**RE: 409 Raymond Avenue
Design Review Case No. PDR 1913301**

**City of Glendale
Community Development Department
Design Review Staff Report – Multi-Family**

Meeting/Decision Date: May 4, 2020	Address: 409 Raymond Avenue
Review Authority: <input type="checkbox"/> DRB <input checked="" type="checkbox"/> ADR <input type="checkbox"/> HPC <input type="checkbox"/> CC	APN: 5626-005-021
Case Number: PDR1913301	Applicant: Art Barsegian
Prepared By: Roger Kiesel	Owner: Editat Argaryan and Serro Navasart

PLOT PLAN

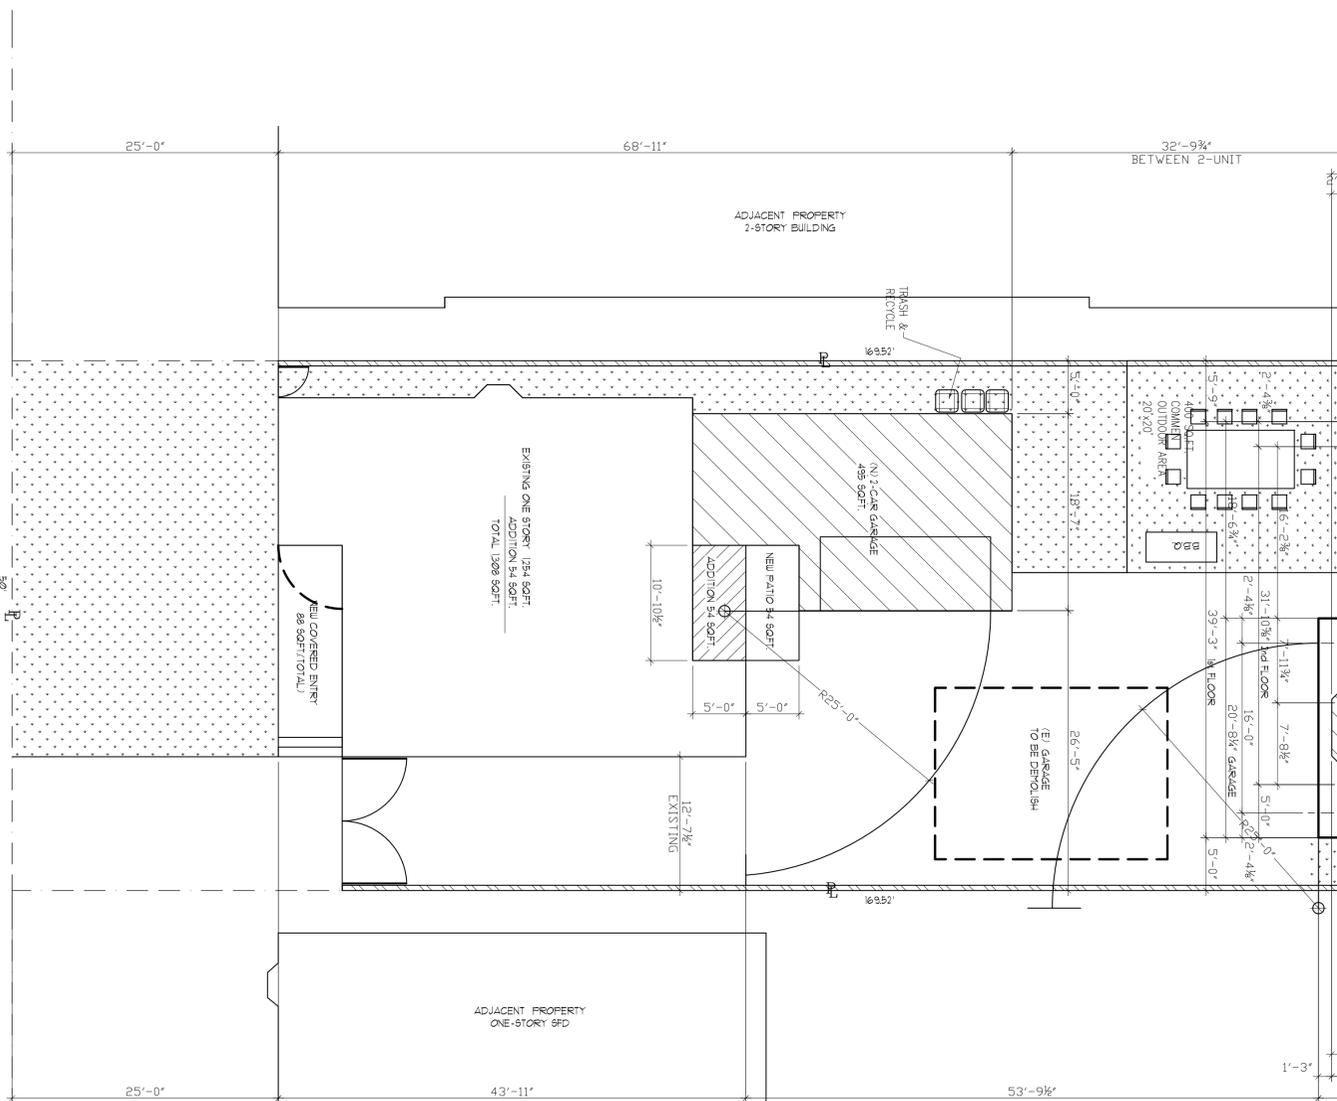
As a condition of approval, the applicant shall provide a sample of the driveway paving material for staff review and approval.

The front yard landscaping is not in good repair and the remainder of the on-site landscaping is shown as lawn. Landscaping needs to be complementary to and acknowledge development of the site. The applicant shall provide landscape plans for review and approval by staff which complement the modest mid-century front home, provide drought-tolerant plant material and buffer the subject site from the adjacent neighbors, to the extent feasible.

Staff is requiring as a condition of approval to provide a driveway paving sample, preferably permeable, for review and approval.

1. Submit landscape plans for the site for review and approval by staff, which complement the style of the development, use drought-tolerant planting and provide buffer between the site and the adjacent neighbors.
2. Provide a sample of the driveway paving material for staff's approval.
